T10/06-451 revision 2

Subject: SAS-2: SAM-4: Miscellaneous State Machine Fixes

Figure 2 — SL (link layer for SAS phys) state machines (part 2)

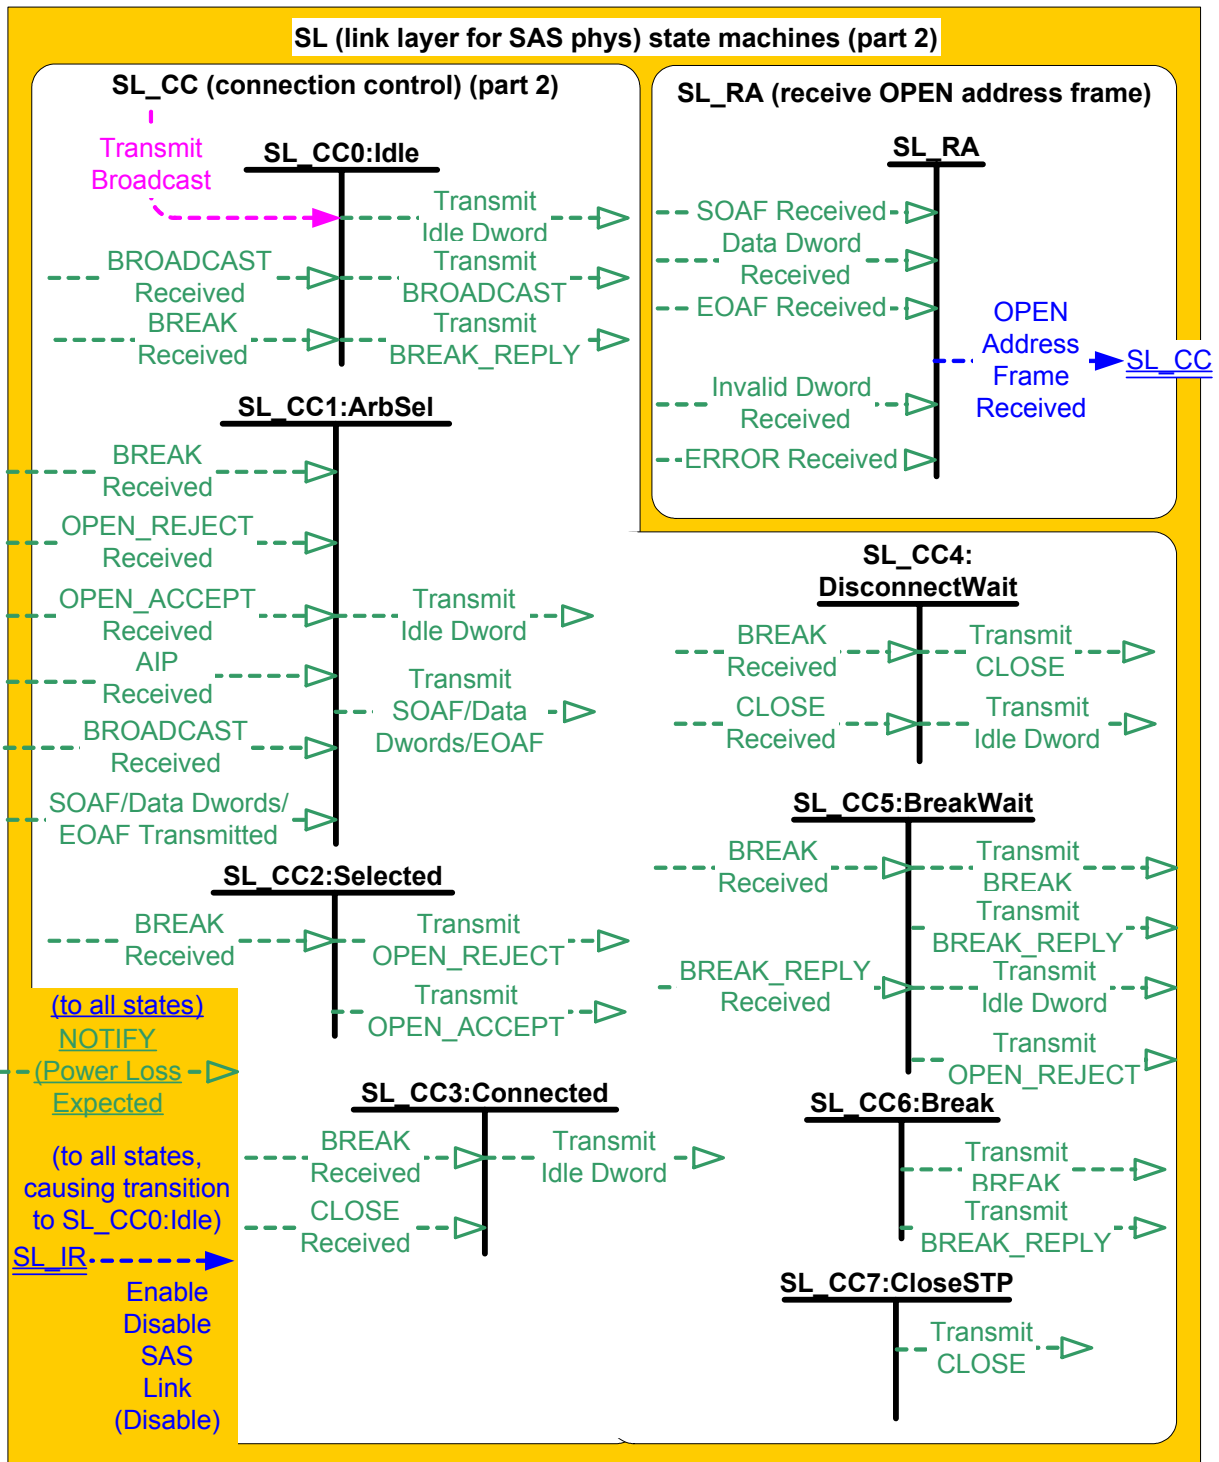
- a) SOAF Received;
- b) Data Dword Received;
- c) EOF Received;
- d) BROADCAST Received with an argument indicating the specific type (e.g., BROADCAST Received (Change));
- e) BREAK Received;
- f) BREAK_REPLY Received;
- g) OPEN_ACCEPT Received;
- h) OPEN_REJECT Received with an argument indicating the specific type (e.g., OPEN_REJECT Received (No Destination));
- i) AIP Received;
- j) CLOSE Received with an argument indicating the specific type (e.g., CLOSE Received (Normal));
- k) ERROR Received;
- l) [NOTIFY \(Power Loss Expected\)](#); and
- m) Invalid Dword Received.

If a NOTIFY (Power Loss Expected) message is received then this state shall send a Notify Received (Power Loss Expected) confirmation to the port layer.

Figure 3 — PL_OC (port layer overall control) state machine

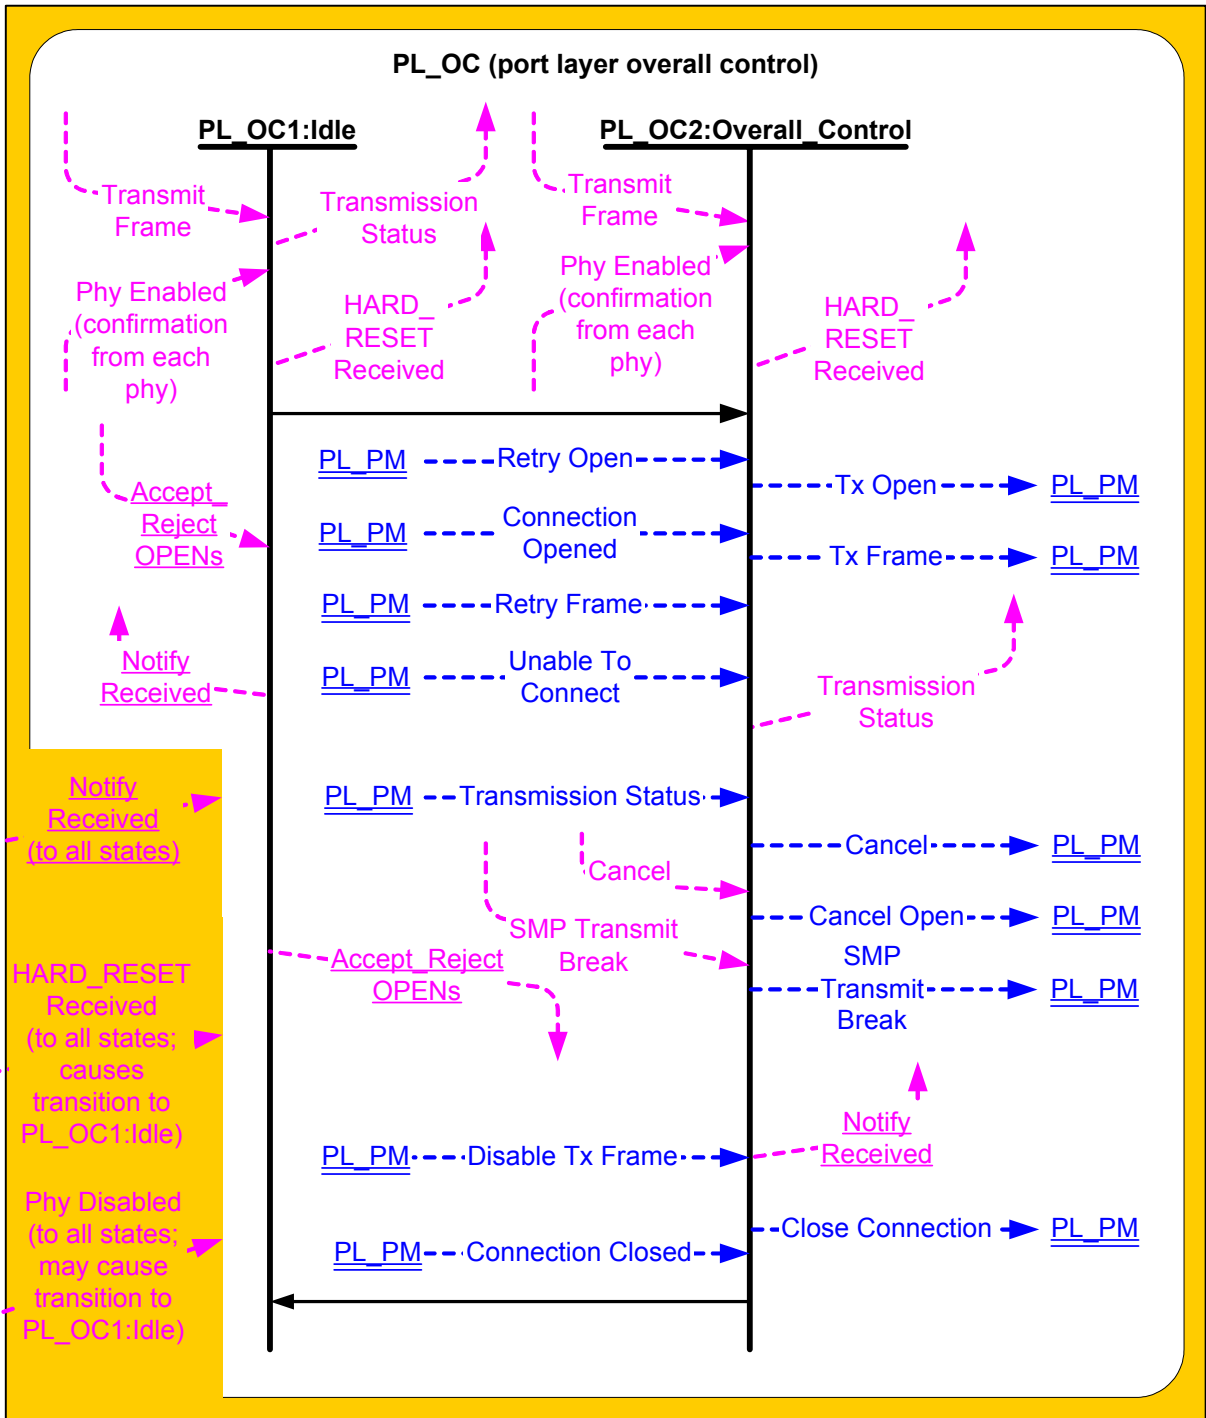
- a) discard all pending Tx Frame messages;
- b) delete all I_T Nexus Loss timers;
- c) send a Close Connection message to all the PL_PM state machines;
- d) send a Cancel Open message to all the PL_PM state machines; and
- e) send a Notify Received (Power Loss Expected) confirmation to the transport layer.

Figure 4 — ST_T (transport layer for SSP target ports) state machines

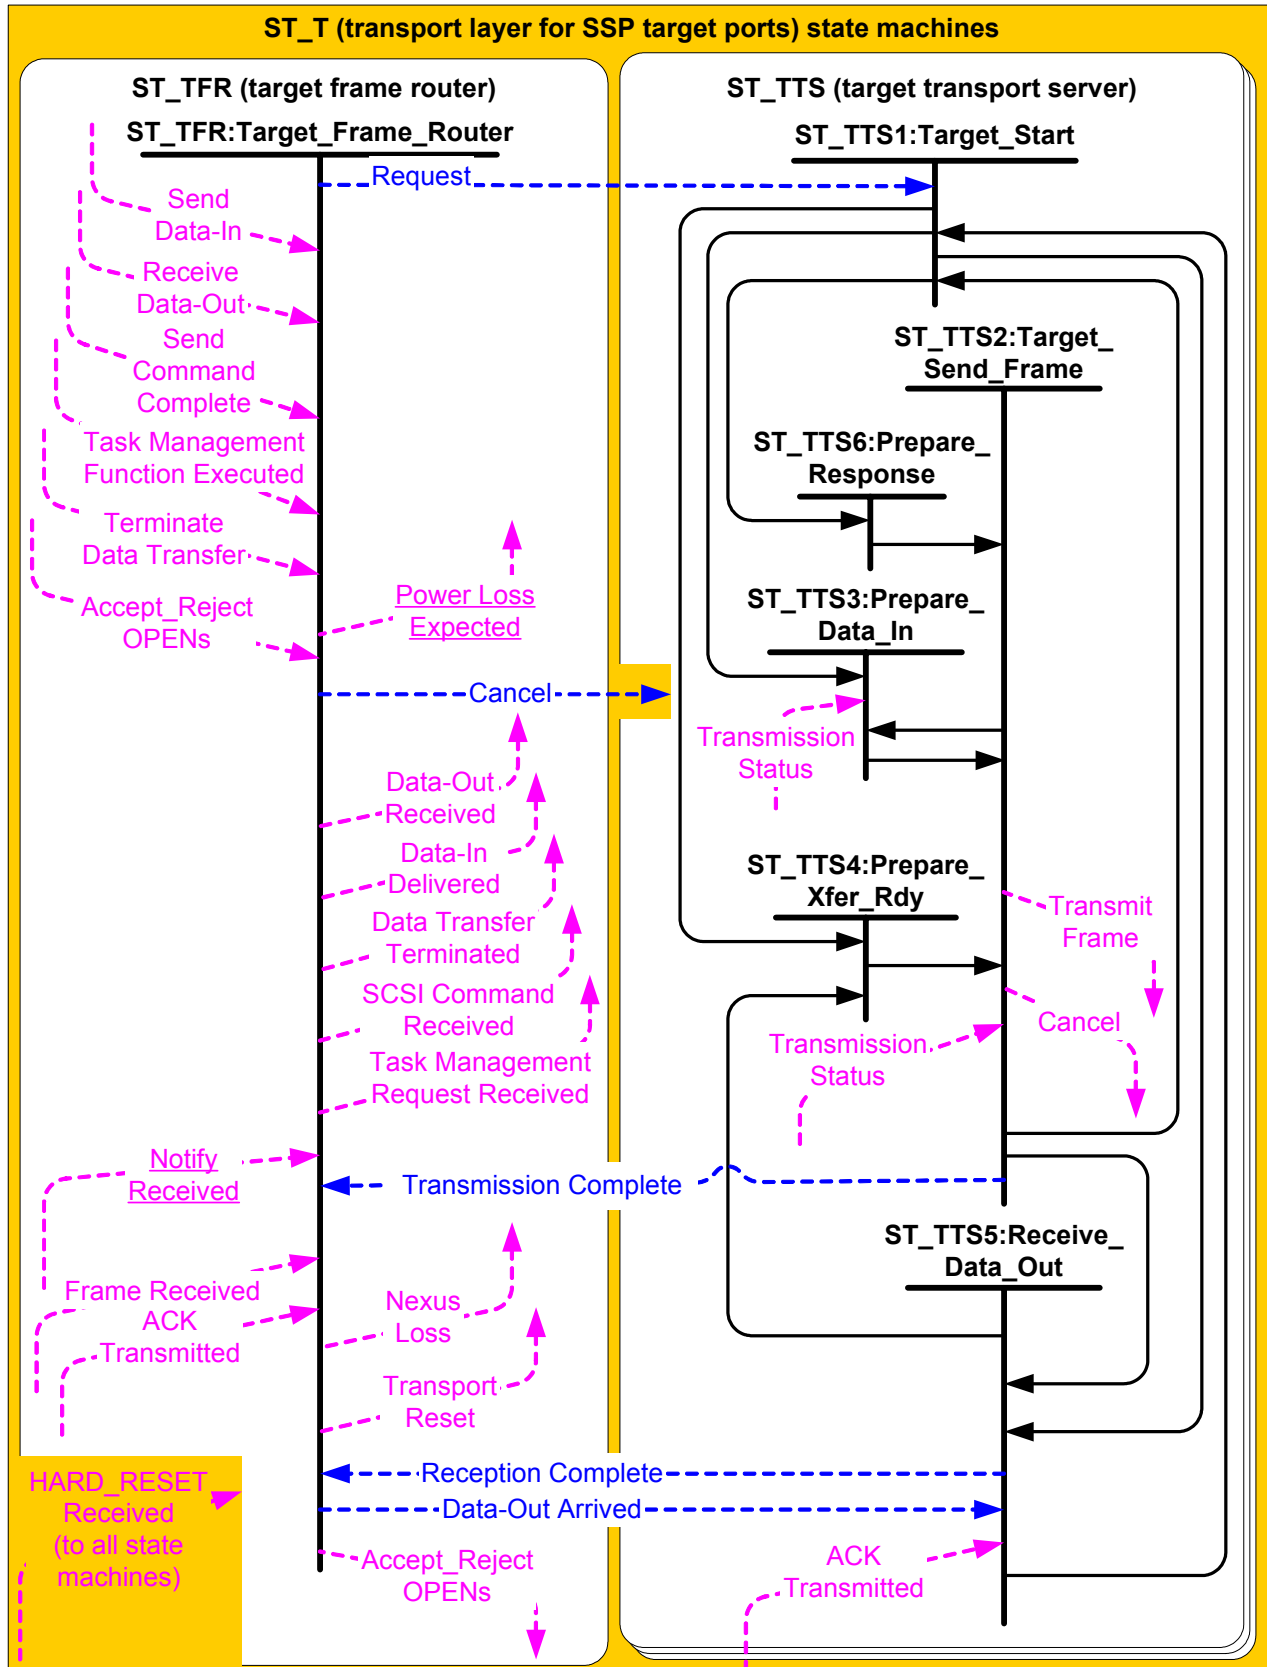
Editor’s Note 2: There needs to be a Transmission Status confirmation arrow added to the ST_TTS5: Receive_Data_Out state in the ST_T state machine figure.

Figure 5 — Events and event notifications for SCSI target devices

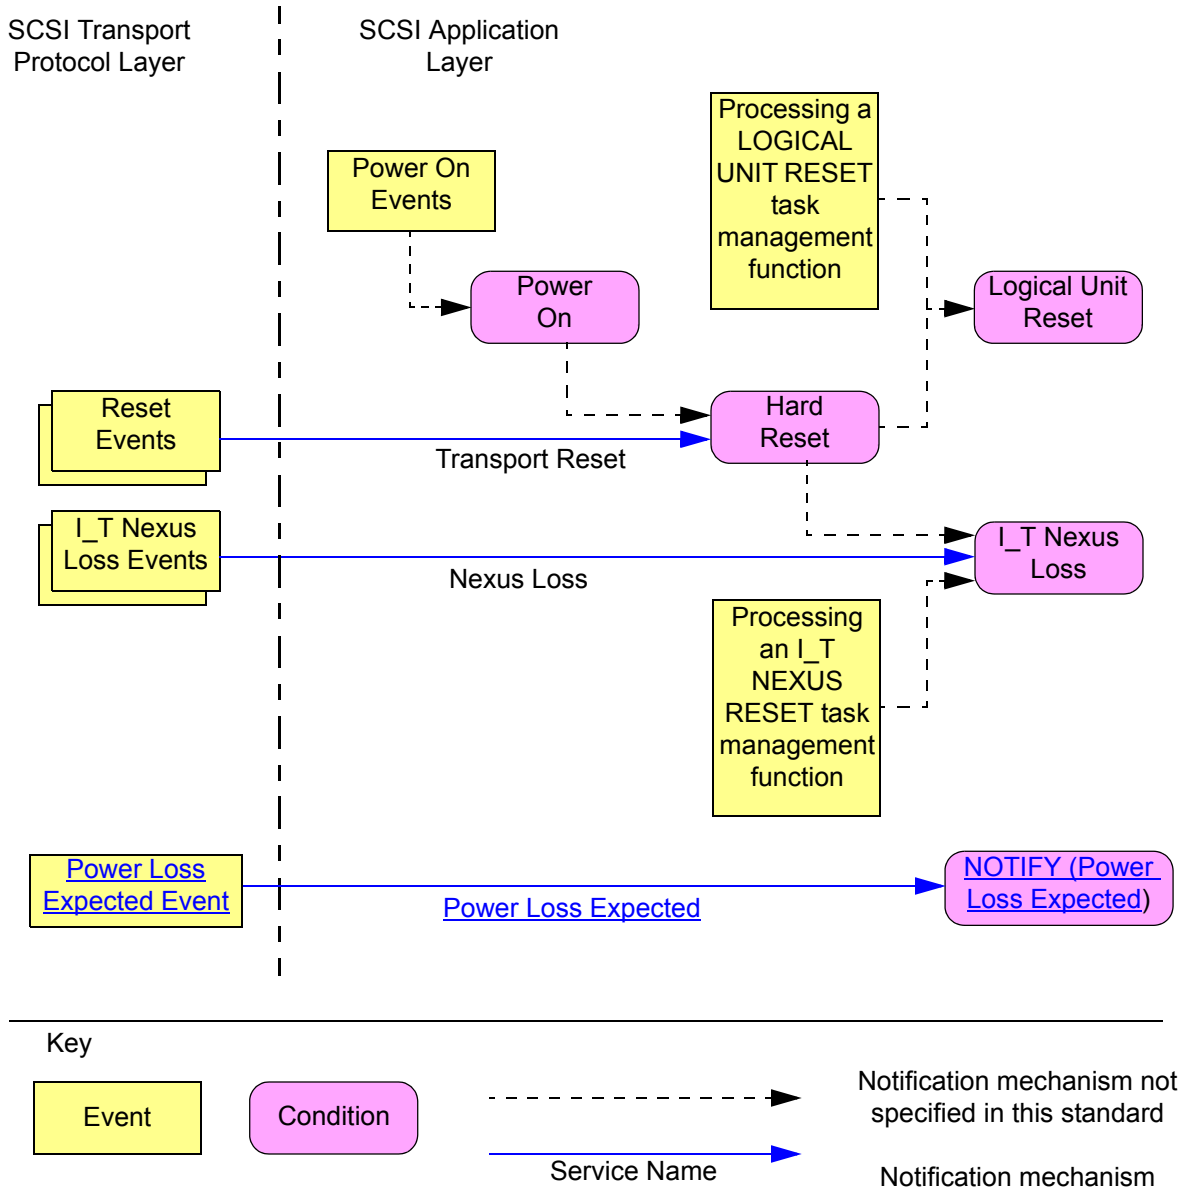
The events detected and event notification services usage depends on whether the SCSI device is a SCSI target device (see figure 5) or a SCSI initiator device (see figure 6). ~~SCSI target/initiator devices shall use the event notification services defined for both SCSI target devices and SCSI initiator devices.~~

When a SCSI target port detects a power loss expected, a **Power Loss Expected** event notification indication shall be delivered to each logical unit to which the I_T nexus has access. In response to the resulting I_T power loss expected condition a logical unit shall take the following actions:
